Product Change Notification (PCN)

Date: 02.04.2020
No.: T-1436

Narrow Pitch Connectors P5K, P5KS, P5KF and P4

Notification change of embossed tape specification.

Changes to embossed tape specifications

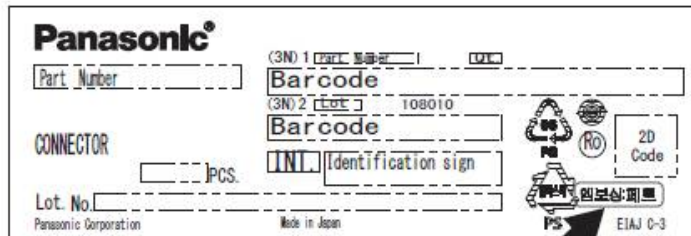
Before change	After change
P5K	Material	PET	PS
	Thickness	0.40 mm	0.30 mm
P5KS	Material	PET	PS
P5KF	Material	PET	PS
P4	Material	PET or PS	PS

*Thickness will also change for P5K.

*There is a partial change to the pocket shape. However, there is no change to the pilot hole or pitch dimension between products.

■ Changes to label

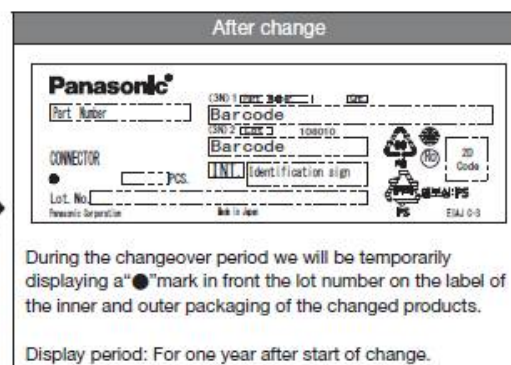
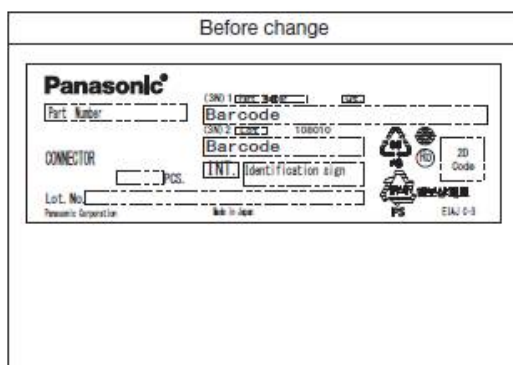
After changing the embossing material, the Korean packaging recycle mark on the inner packaging label will change.

(There will be no change to the outer packaging label.)

엠보싱:페트 Embossed: PET

엠보싱:PS Embossed: PS
